**AMENDMENTS TO THE DRAWINGS**

### REMARKS

**Title:** DRUM-TYPE WASHING MACHINE

FIG. 1

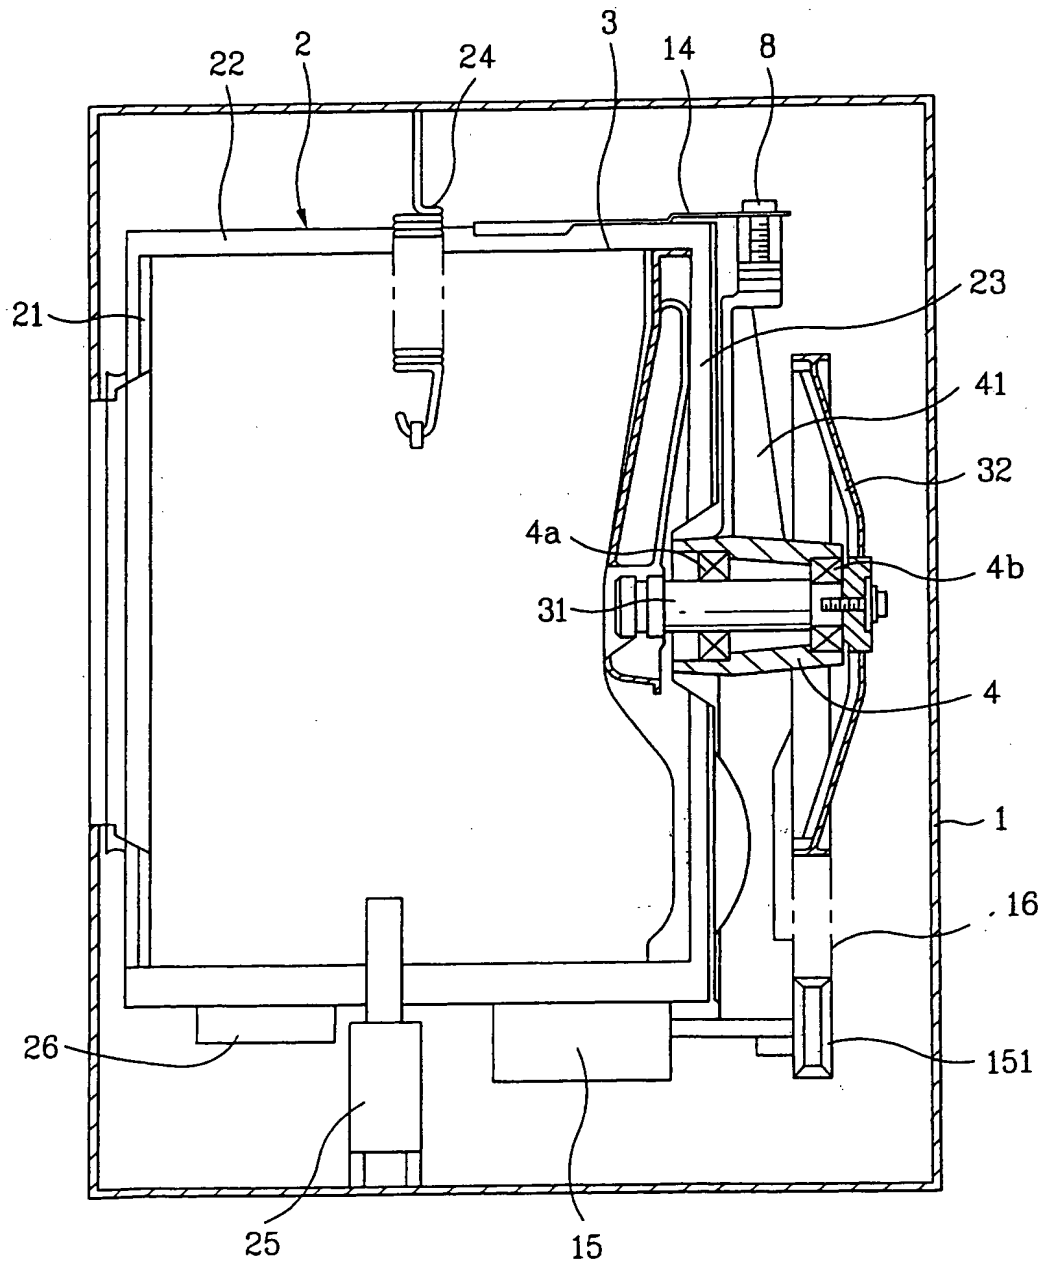
The drawings have been amended as follows. In Figures 1-3, the label "Related Art" has been added to the figures. The Applicants respectfully request the objection be withdrawn.

The attached sheets of drawings include changes to Figs. 1-3. These sheets replace the original sheets. The following changes have been made to Fig. 1-3. The legends "Related Art" have been added to the figures.
